# Product Change Notice

Retail Part Number	Bulk Part Number	Product Description
PS8-250ATX-ZE	96PS-A250WPS2	80 Plus Bronze 250W PS/2 Single Power Supply

### Product Design Change in Product Appearance

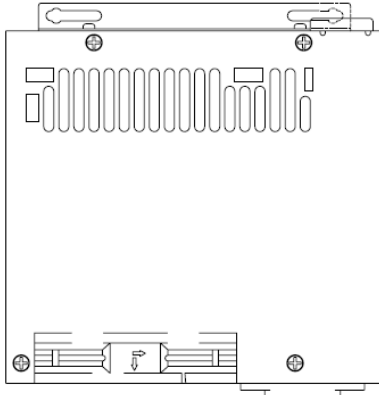
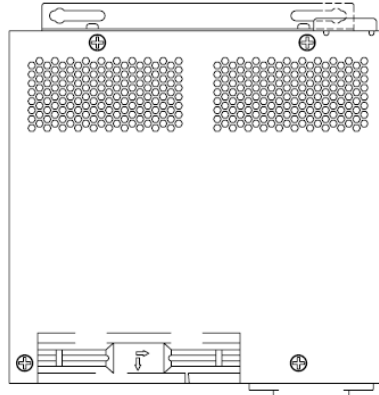
We have recently implemented below product change to meet safety standard IEC/EN 62368-1, which will be mandatory to replace IEC/EN 60950-1 since 2020/12/20, especially in Europe. This announcement takes effective immediately. Please review this notice carefully and contact with product manager or your regional PAPS representatives, should you have any question.

**Current:****Ventilation area: 4487.6mm<sup>2</sup>****Ventilation area: 1776mm<sup>2</sup>****Ventilation area: 3739.5mm<sup>2</sup>****New:****Ventilation area: 5274.9mm<sup>2</sup>****Ventilation area: 1920.3mm<sup>2</sup>****Ventilation area: 2712.5mm<sup>2</sup>**
